# CONFERENCE REPORT

**PROJECT:** Dover-Somersworth-Rochester 29604      **DATE OF MEETING:** March 5, 2020  
(MJ Project No: 18288.00)

**SUBJECT:** Working Group Meeting #3

***NH Route 108 Complete Streets Improvements  
Dover-Somersworth-Rochester 29604***

## Purpose

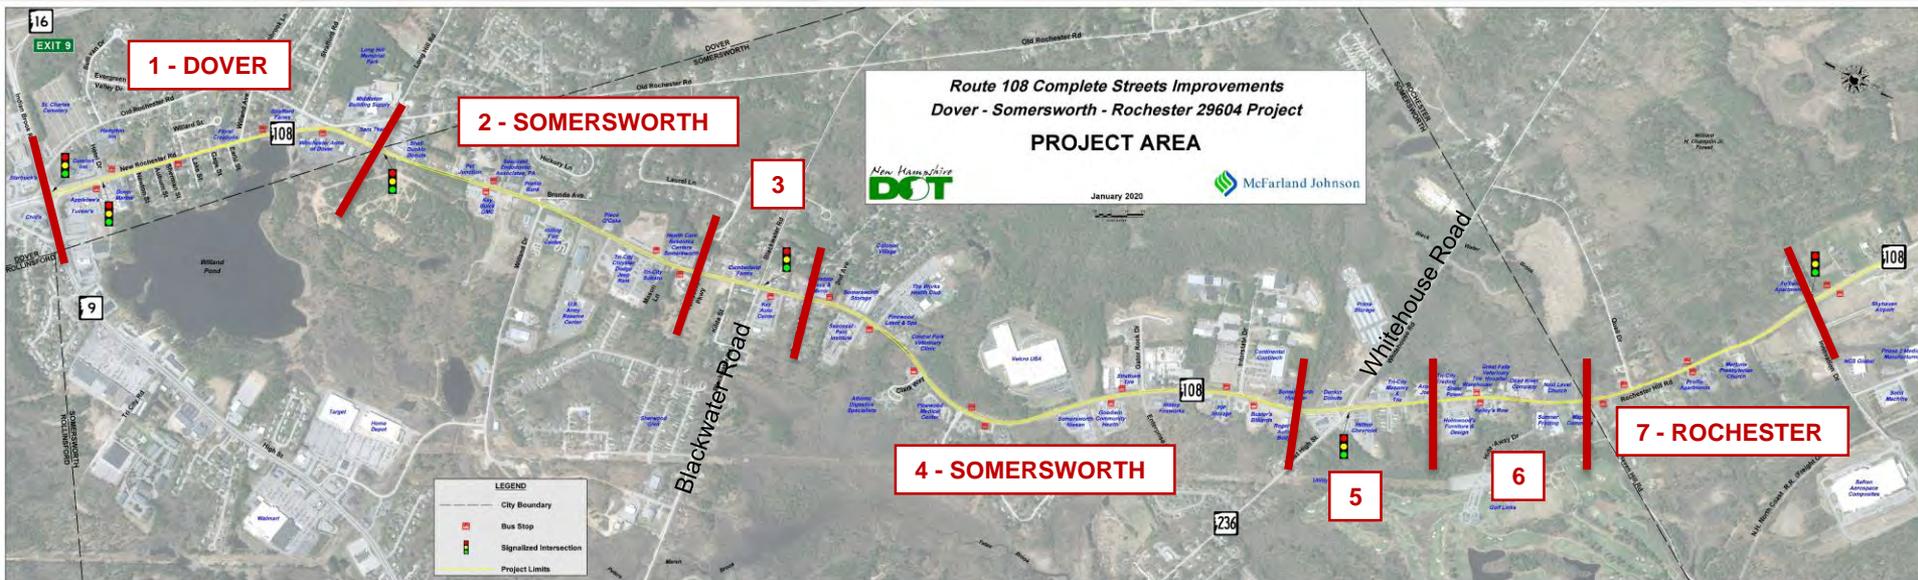
- G. McCarthy stated that the language regarding “quality of life” was not added to the purpose statement as it is subjective. He reiterated that the core of the project is a Complete Street and didn’t want that to get lost during design.

- Discussion turned to the Purpose statement language regarding active and mass transit. The decision was made to change the Purpose statement language from “accommodate” to “is designed for” with pedestrian, bicycle and public transit use prioritized before trucks and cars.

- It was noted by the group that the project should also be sustainable with limited maintenance and salt tolerant landscaping.
- W. Johnson asked the group if a new bullet point under Need was warranted to address maintainable facilities. The discussion that followed concluded that language should be added to the purpose to consider future maintenance.

**Concept A (With Grass Strip):** Three Lanes with Dual Sidewalks

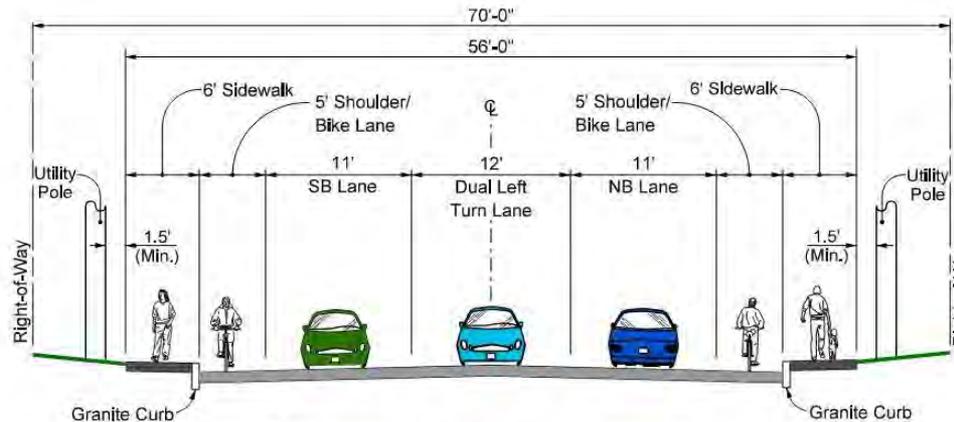
- G. McCarthy mentioned that the intent is to calm traffic and not to create an environment which encourages drivers to speed.
- Concept A has a 3-lane section with sidewalks on both sides. This concept is broken into two similar typical sections. A1 has 5' grass strips between the shoulders and the 5' sidewalks whereas A2 has no grass strip and 6' sidewalks.

- It is more likely that the typical section with the grass strip will be the standard typical and will be narrowed in locations of sensitive resources such as cemeteries.

- The typical section with the grass panel also allows for more sustainable maintenance as there is room for snow storage.
- Concept B incorporates the 3-lane section with a single sidewalk; B1 with a 5' grass strip and 5' sidewalk while B2 has no grass strip and 6' sidewalk.

**Concept C : Three Lanes with Single Multi-Use Path**

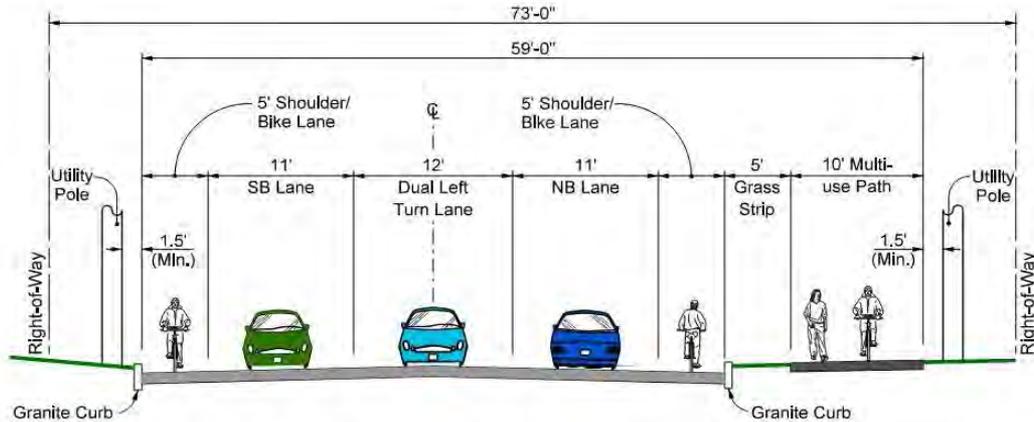
- Concept C has the 3-lane section with a 5' grass strip and a 10' multi-use path on one side.
- Concept D has the same typical section as Concept C with the addition of a sidewalk on the opposite side of the road.

- C. Parker inquired as to the inclusion of the bike shoulder with the 10' multi-use path. This was maintained in part because the shoulder would already be there and to accommodate cyclists of all levels (avid and timid).

Route 108/Blackwater Road  
3 Lane Concept

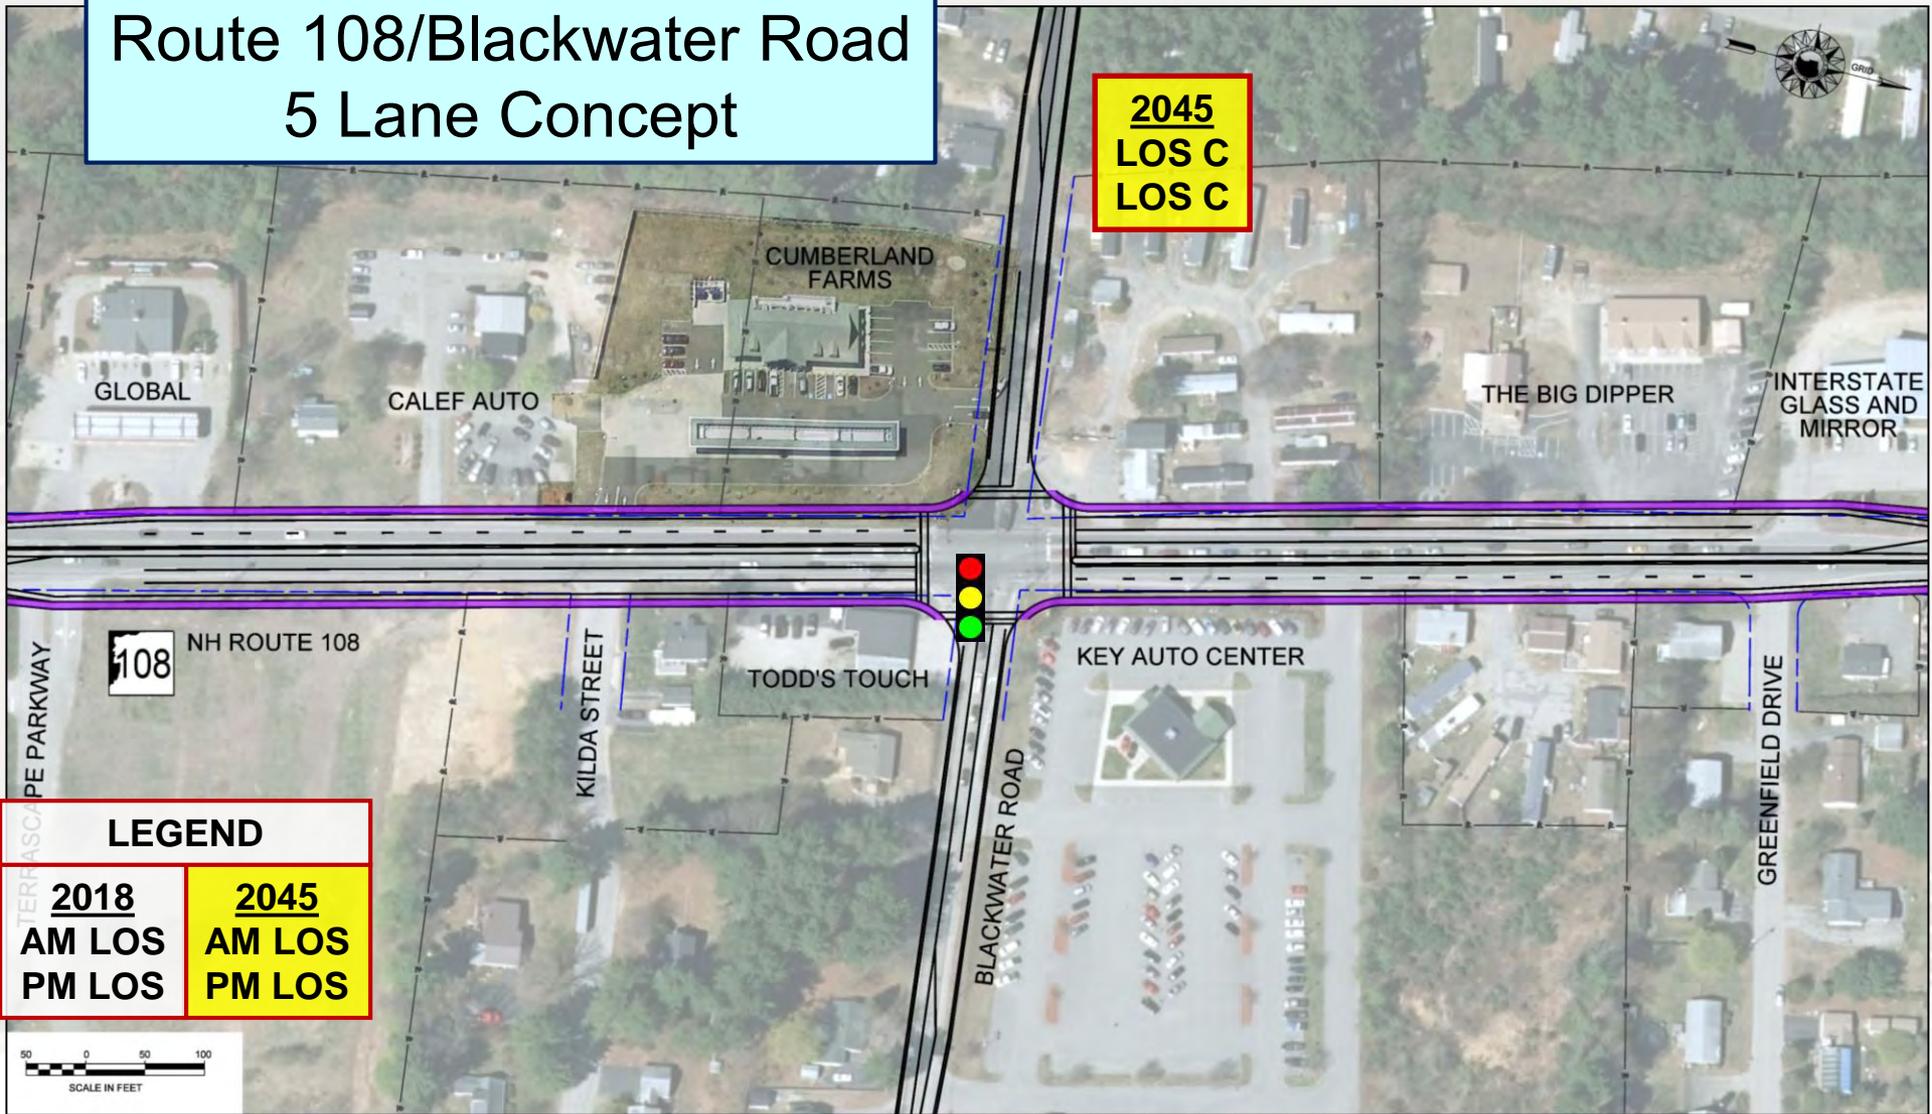
- 3-lane section will be a worse Level of Service (LOS) in 2045 than existing is currently.
  - 5-lane section is marginally better than the 3-lane section but with significant ROW impacts.

Route 108/Blackwater Road  
Roundabout Concept

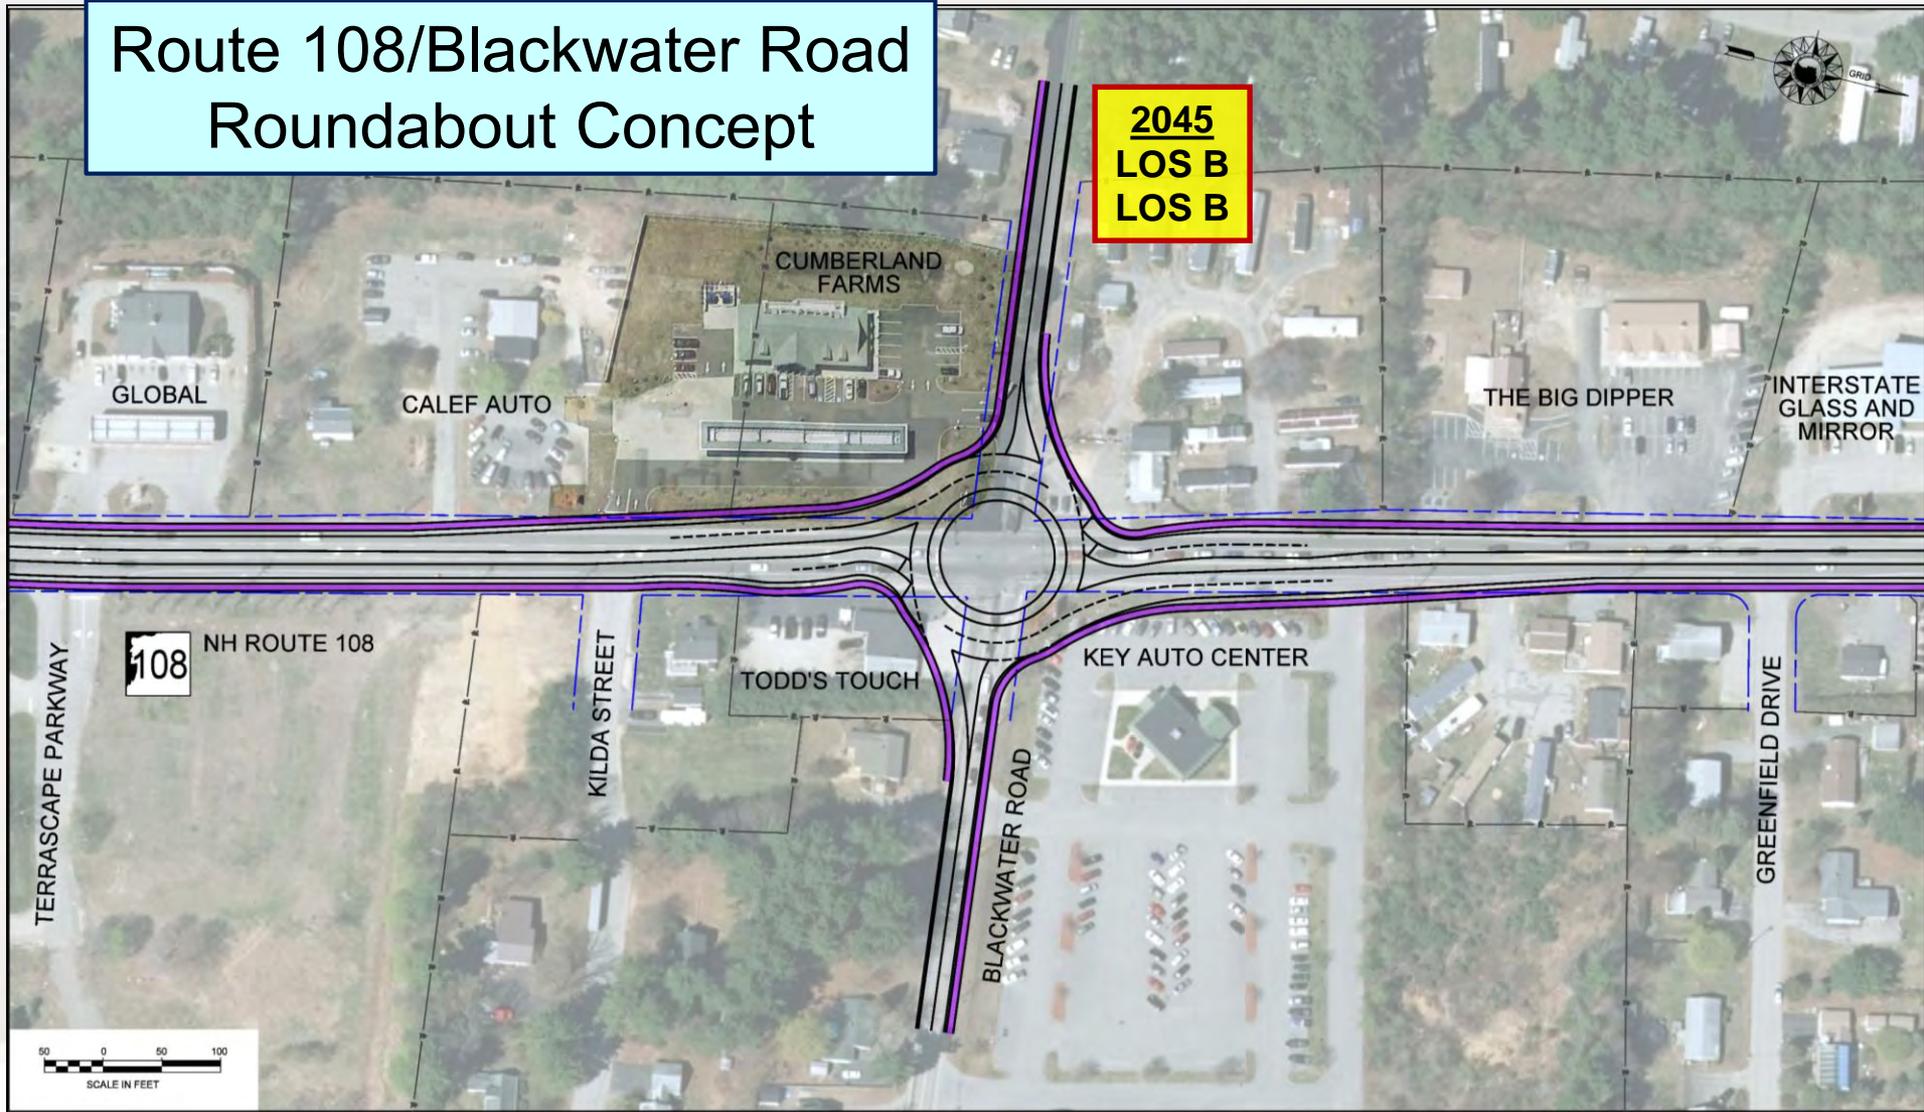
- 2-lane roundabout offers the best traffic operations but has significant ROW impacts.
    - It was noted that a single-lane roundabout returned a LOS F in 2045

Route 108/Whitehouse Road/  
West High Street  
3 Lane Concept

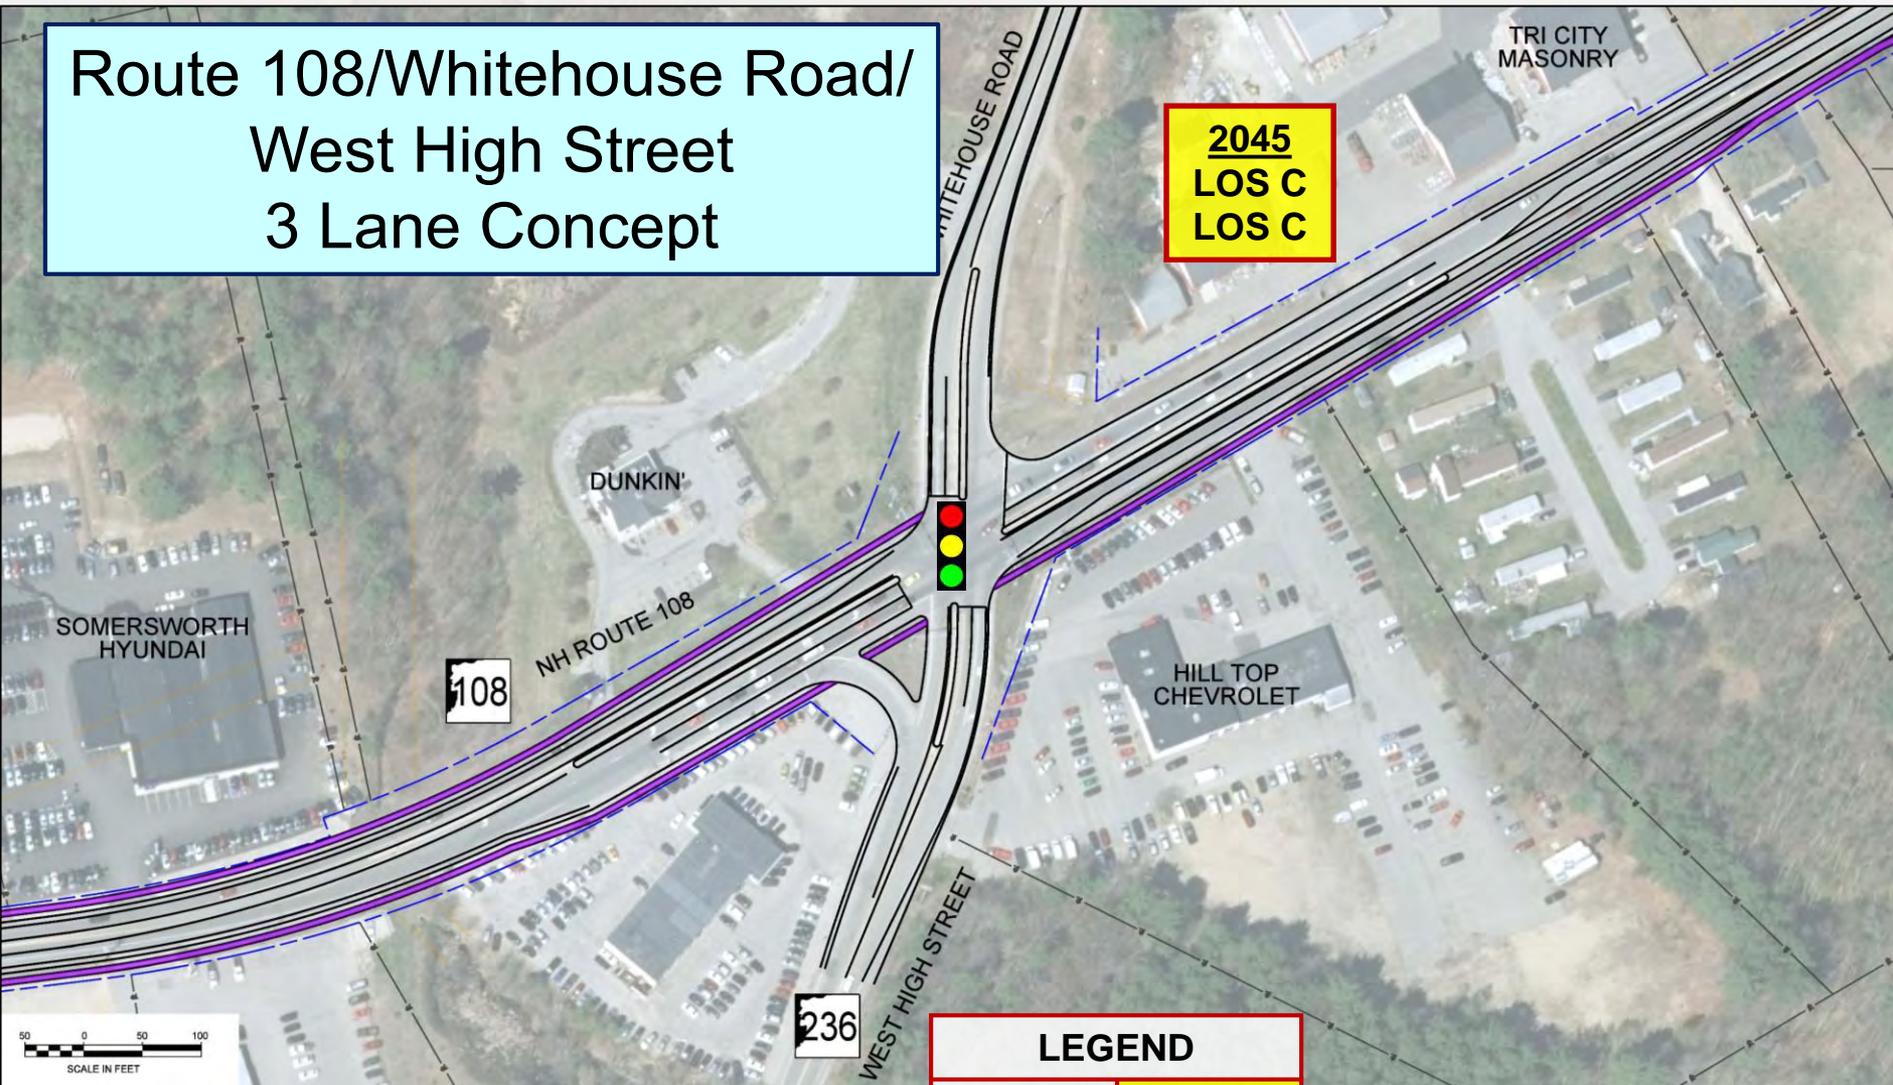
- Proposed 3-lane and 5-lane sections function slightly better than existing
  - A good location for a roundabout.
